# EXHIBIT 15

## Comments on the Whistling Ridge Wind Energy Power Project DEIS Skamania County, Washington

K. Shawn Smallwood, Ph.D.

27 August 2010

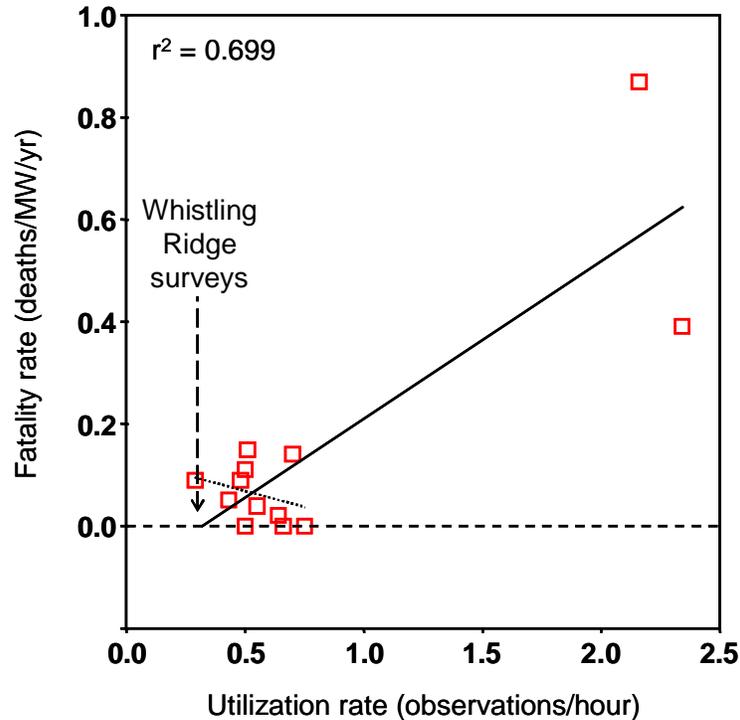
WEST, Inc. relied on a regression relationship (Figure 8 in App. C-4) that regularly appears in their environmental documentation in support of wind energy projects, and which I have commented on before (see Figure 1, below). Affirming its reliance on the WEST, Inc. approach to assessing potential project impacts, the DEIS (page 3-63) stated, “Mean overall bird use in the study area was low compared to these other wind resource areas studied: ranking 19<sup>th</sup> compared to 24 other wind resource areas...” and, “Mean annual raptor use was 0.28 raptors per plot per 20-minute survey, which is a standardized way to measure use in order to compare results to avian use at other sites.” However, this approach was inappropriate for use as a predictive tool due to multiple fundamental flaws, which are addressed in the following paragraphs.

**Sufficiency of survey effort.**—The vertical dashed arrow in Figure 1 represents the utilization rate that WEST, Inc. estimated for raptors at the Whistling Ridge project site. Although a non-biologist might be impressed with the number of bird surveys performed at the Whistling Ridge project site, totaling 261 surveys, biologists familiar with utilization surveys at wind project sites have cause for concern regarding conclusions drawn from the level of effort devoted to Whistling Ridge. The 261 surveys lasted 20 minutes each, so totaled 87 hours. Eighty-seven hours was insufficient time to detect multiple raptor species and many other bird species, especially considering the high levels of visual occlusion due to forest cover surrounding observation stations at Whistling Ridge, along with the large volumes of airspace that would have been occluded due to mountainous terrain and cloudiness.

**Pseudoreplication.**--The regression relationship in *Figure 8* of App. C-4 likely exemplifies pseudoreplication in correlation analysis, which is a fundamental experimental design flaw that is routinely warned against in statistics textbooks.<sup>7</sup> The regression is based on two clusters of data, one from wind projects located mostly in the Pacific Northwest and the other from two projects located nearby each other in California. If the variation in the graph was more representative of the two regions -- Washington/Oregon versus Central California -- than of the individual project sites, then the sampling units were really the regions and not the project sites. In presenting their graph, Johnson and Erickson (2008, 2010) presented a value for the coefficient of determination, *r*<sup>2</sup>, but they neglected to present an error term. Furthermore, they presented the relationship as significant, and the DEIS repeated that conclusion along with the prediction, based on the regression, that 0 raptors would be killed by Whistling Ridge wind turbines (page 3-79).

**Figure 8.** Fatality rate estimates regressed on utilization rate estimates after including data from additional WRAs to those used by WEST, Inc.

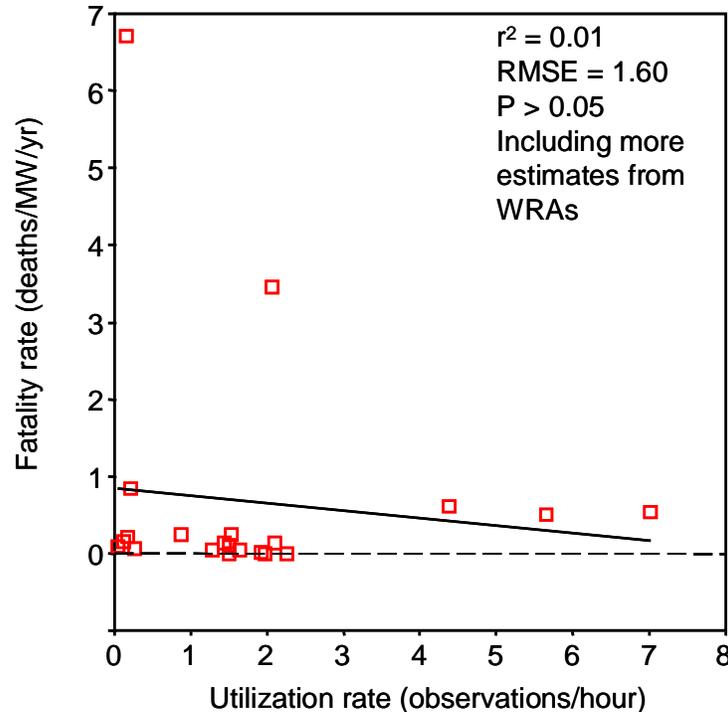
**Regression relationship based on selective inclusion of data.**—*Figure 8* of App. C-4 was based on only some of the wind projects for which there exists fatality rate and utilization rate estimates. Including more of the estimates available, the regression slope reported by Johnson et al. in the Whistling Ridge DEIS no longer applies (*Figure 8*).
